The Reserve at Wyoming Springs - Rezoning
ZONING ZON1802-007

DATE OF REVIEW: March 21, 2018

STAFF REVIEW AND ANALYSIS:

TITLE:
WYOMING SPRINGS CONCEPT PLAN

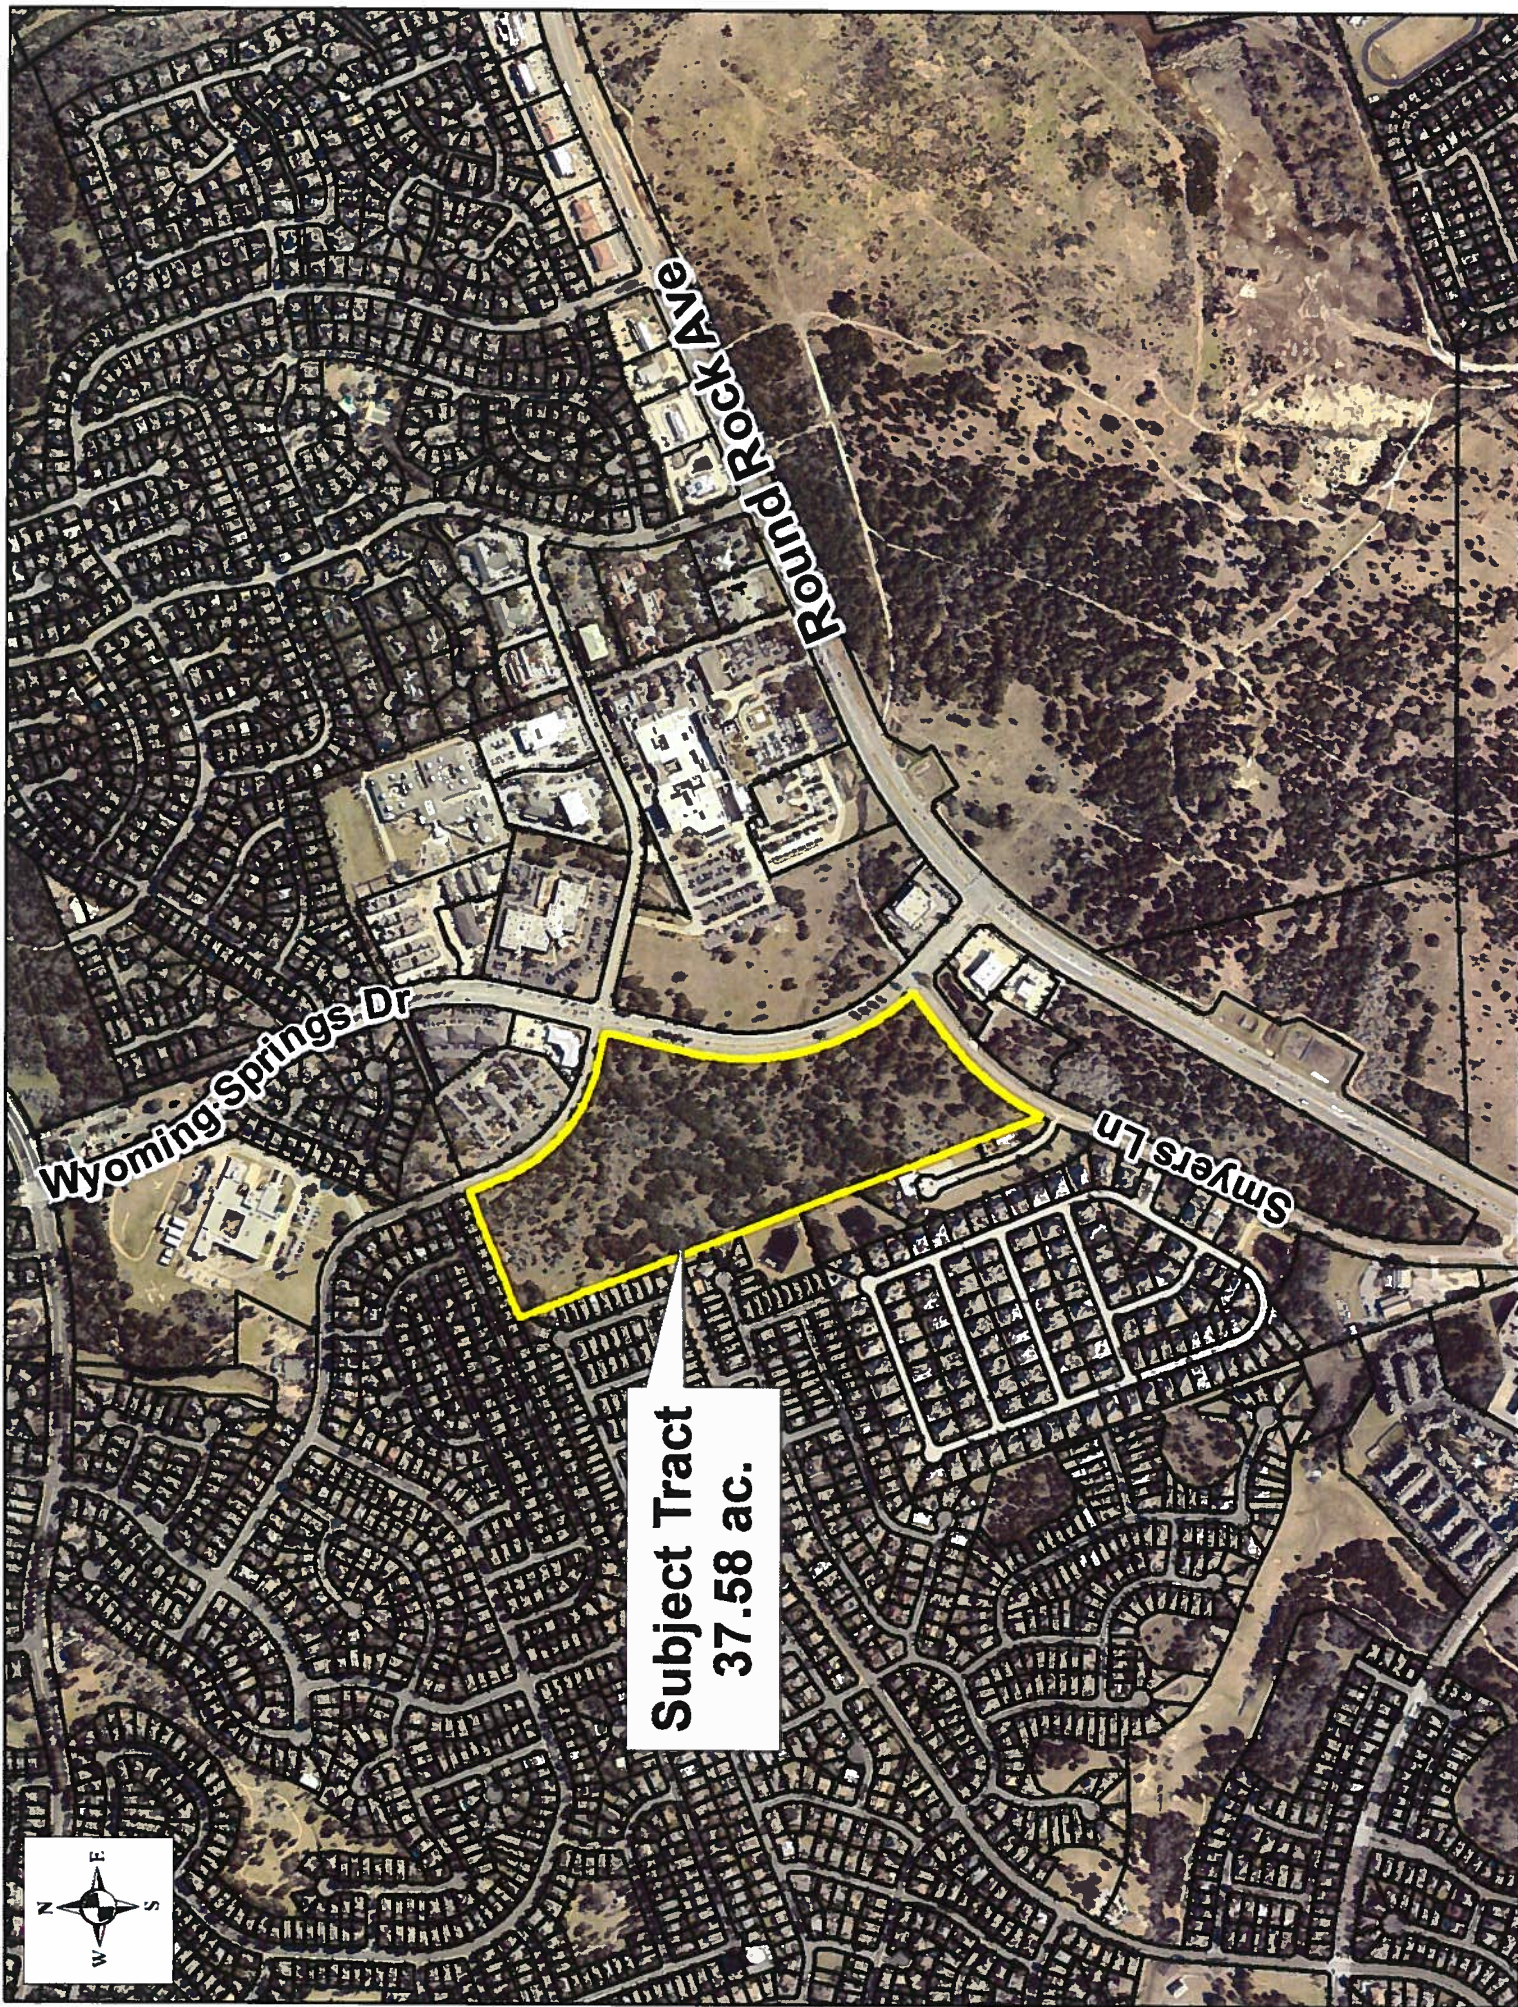
Draft site layout: The draft site layout prepared by the developer indicates that the project will provide both estate lots and standard lots, with no small lots. The layout results in a connectivity index of 1.08, which is less than the minimum requirement of 1.35. The site has several karst features and is crossed by a significant drainage swale, which makes connecting the two parts of the property impractical. The swale contains ultimate 1% annual chance floodplain, which would make a crossing cost prohibitive. The connectivity section of the code allows for an index of less than 1.35 in this situation. The layout also indicates that Liberty Walk Drive, which stubs out on the eastern border of the tract, will be extended across the site to Park Valley Drive.

Staff recommends approval of the rezoning from the OF (Office) district to the SF-3 (Single Family – mixed lot) district.
